REMARKS/ARGUMENTS

Gray Cary\EM\7176003.1 2102475-991110 Appl. No. 09/821,163 Docket No. 2102475-991110 Response to Office Action of July 26, 2004

Amendments to the Drawings:

Annotated Sheet Showing Changes

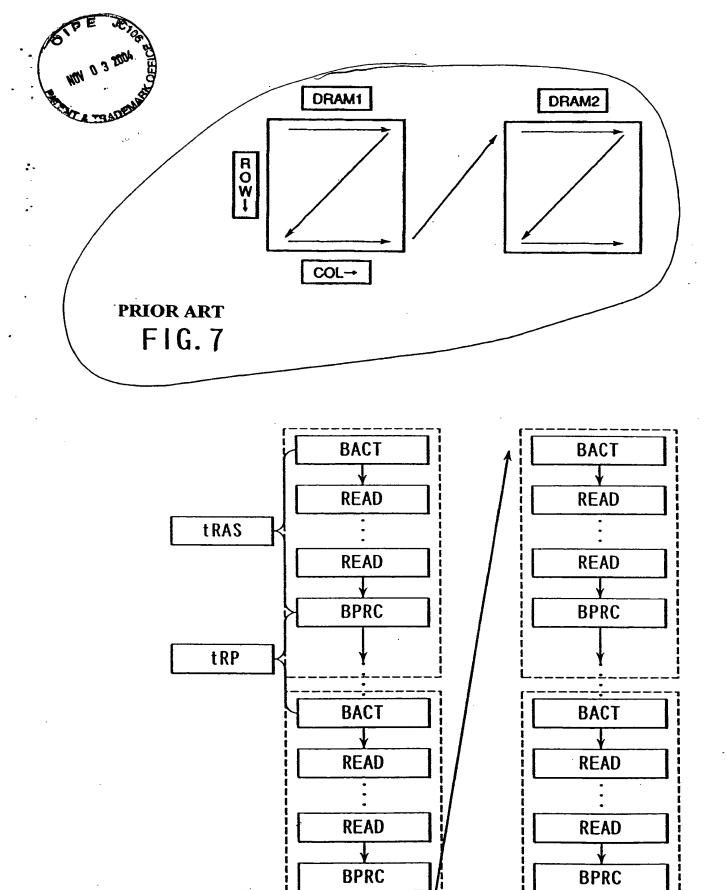
Applicant submits a corrected Figure 7 to replace original Figure 7. Original Figure 7 was erroneously filed instead of the now submitted corrected Figure 7. Applicant notes that original Figure 7 is identical to Figure 2, but does not match Figure 7 of the Japan Patent Application 2000-088408 to which priority is claimed. Further, the original Figure 7 does not correspond to the description in the specification on page 2, line 5 to page 4, line 8. Applicant notes that a copy of the priority document was filed on June 27, 2001. New Figure 7 corresponds to Figure 7 of the priority application Japan Patent Application 2000-088408. Because the priority document is incorporated into the specification by reference (see Application, page 1, lines 4-8), no new matter is added. Acceptance of this drawing change is respectfully requested.

Applicant submits that original Figure 7 is not prior art. As noted above, original Figure 7 is identical to Figure 2 and was erroneously filed. Applicant notes that the description in specification does not describe Figure 7 as originally filed, but instead describes Figure 7 as amended and Figure 7 as filed in the Japan Patent Application from which priority is claimed. Because original Figure 7 is not admitted prior art, this Section 103(a) rejection should be withdrawn.

The attached sheet of drawings includes changes to Figure. 7. This sheet, which includes Figs. 7 - 8 replaces the original sheets including Figs. 7 - 8.
